***MAJOR PROJECT ASSESSMENT:
BALLAST POINT PARK – Ballast Point
Road, Birchgrove***

Director-General's
Environmental Assessment Report
Section 75I of the
Environmental Planning and Assessment Act 1979

August 2006

Figure 4. Pedestrian Accessibility (Source EA Appendix 2 Landscape Report prepared by Anton James Design 8 March 2006)

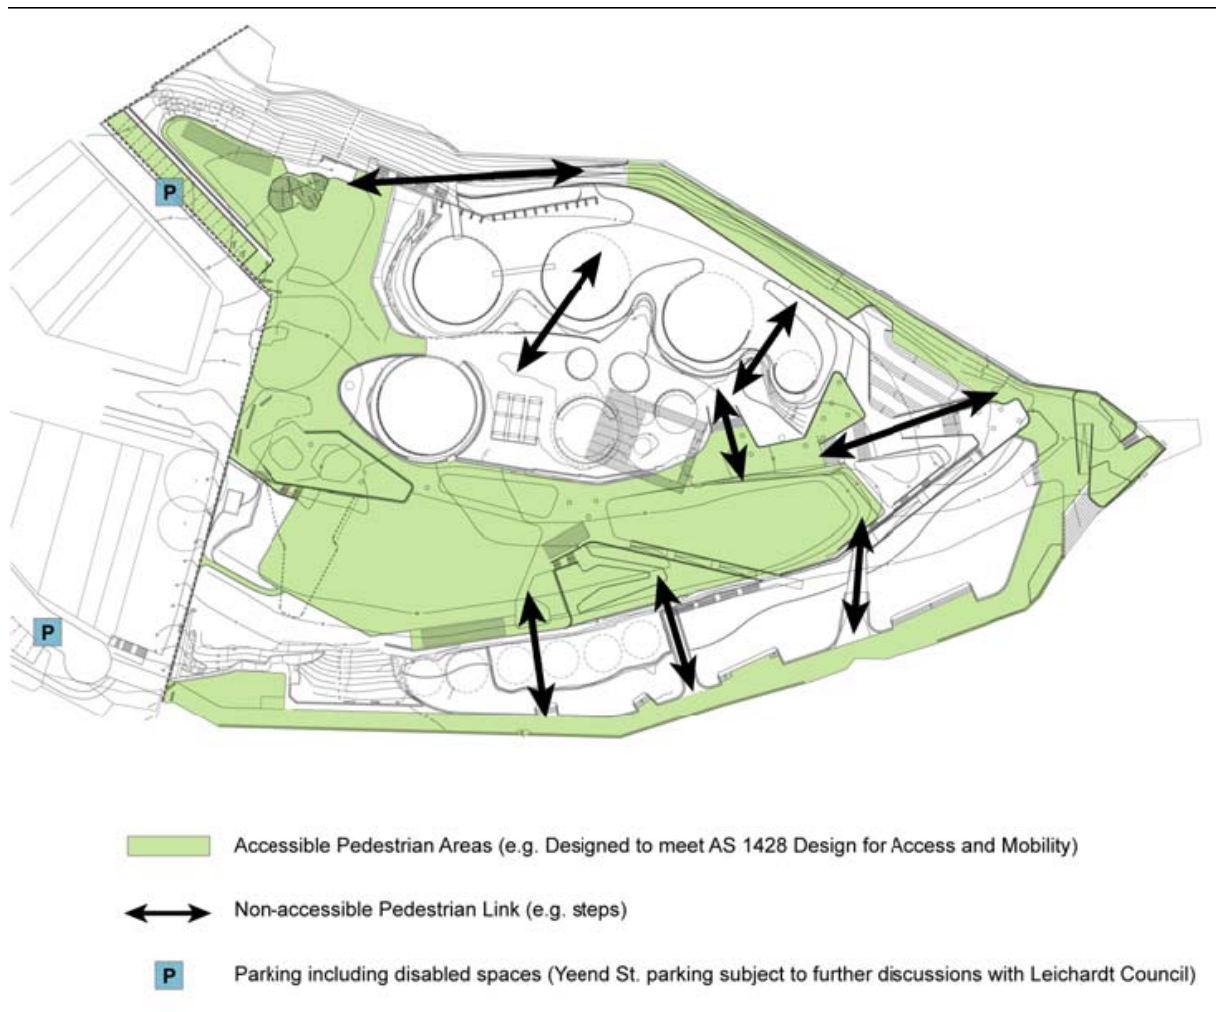
Consideration Access within the park suitable for disabled persons is not available between the upper areas of the site and the lower foreshore promenade (see below Figure 4). Disabled access to the lower areas of the site is currently available from the Yeend Street entry and the proposal relies on future liaison with Leichhardt Council to combine parking for Mort Bay Park and Ballast Point Park to provide additional disabled parking at this lower level. The on site car parking included in the proposal (including 2 disabled spaces) is limited to Wharf Road and this provides access to the upper areas of the site.

The Applicant has provided comments from the landscape architect and an Access Report prepared by Morris Goding Access Consultants (Appendix G). The Applicant submits that providing access ramps between the upper and lower levels internal to the park would severely impact the site, the visual appearance of the site from the harbour, and the quality of the recreational space. The Applicant also submits that provision of a passenger lift within the park would require extensive earth moving works at a high capital cost and may also be subject to vandalism. The Applicant submits consideration of the provisions of the *Disability Discrimination Act 1992* (Cth), and notes Section 23 of the *Disability Discrimination Act 1992* (Cth) recognises that it may not be possible or fair to enforce the requirements of access to premises in all situations. The Human Rights and Equal Opportunities Commission (HREOC) in their Advisory Notes allow for a defence of unjustifiable hardship in situations where provisions of full access within existing premises would prove too demanding because of technical, topographical, safety or financial limits. The Report provided also concludes that it is imperative that accessible parking is made available in Yeend Street.

Resolution The landform of the site and the 17m change in level between the upper and lower precincts of the park create difficulties in providing disabled access within the site. As in paragraph 6.1.1 above, further consultation with Council regarding future parking facilities is encouraged, however this assessment cannot consider or require any proposed parking in Yeend Street as the area falls outside the boundary of the Ballast Point site and will be subject to a separate planning approval. It is considered that separate disabled access provided to the upper and lower levels of the park is satisfactory as access between the levels that is internal to the park is not feasible. Condition B6 has been proposed to require the Proponent to provide access for people with disabilities in accordance with Part D3 of the BCA's Access Policy and the provisions of the *Disability Discrimination Act 1992* (Cth).
